## PRODUCT/PROCESS CHANGE NOTICE (PCN)

<b>PCN #:</b> <b>TB1405-01</b> <b>DATE:</b> <b>July 7, 2014</b> <b>Product Affected:</b> <b>TQFP-44, TQFP-64</b> <b>shipped in Tape &amp; Reel</b> (Refer to Attachment II for affected part#) <b>Date Effective:</b> <b>October 7, 2014</b>	<b>MEANS OF DISTINGUISHING CHANGED DEVICES:</b> <input type="checkbox"/> Product Mark <input type="checkbox"/> Back Mark <input type="checkbox"/> Date Code <input checked="" type="checkbox"/> Other        Shipment starting from October 7, 2014.
--	--

### ATTACHMENT I - PCN #: TB1405-01

**Detail of Change:** This notification is to advise our customers that IDT has planned to convert to a new revision of the carrier tape and to standardize the quantity per reel.

**From:** Carrier Tape (P8-300-E64) - Pocket Dimensions

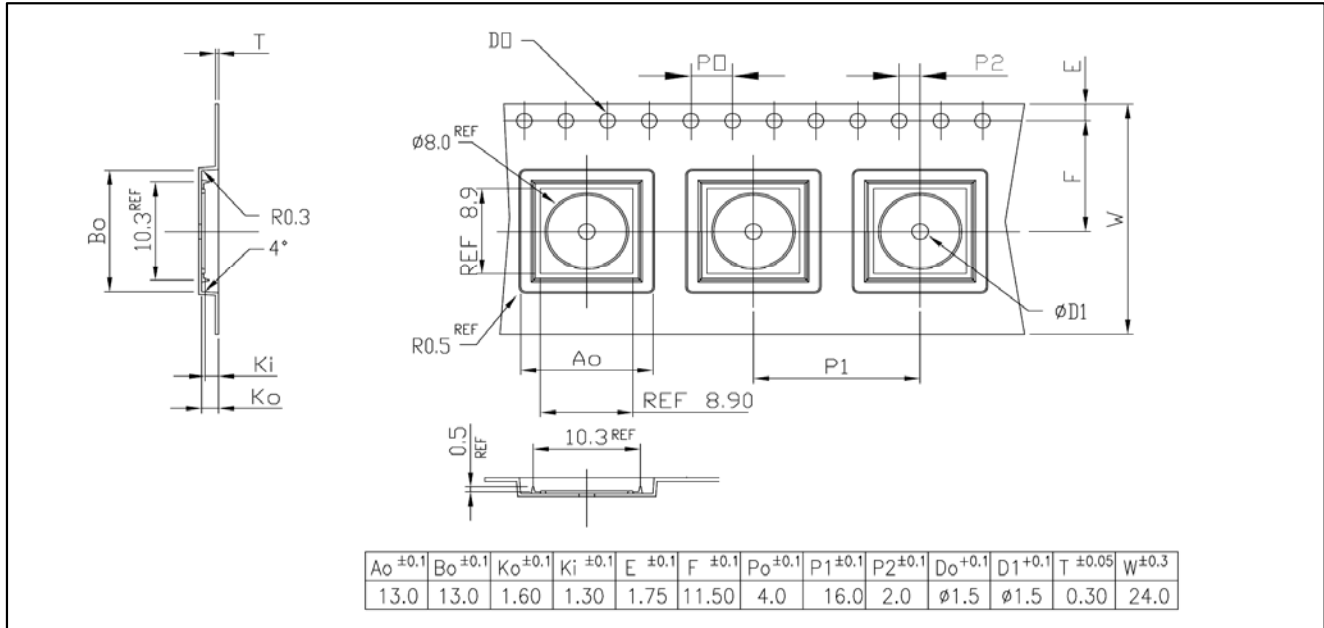
The new carrier tape has changes in pocket design and dimensions and complies with the requirements of EIA-481-D standard.

Refer to Table 2, Figure 1 and 2 for the comparison of the existing and new carrier tape in terms of carrier tape pocket dimensions and pocket designs as well as quantity per reel respectively.
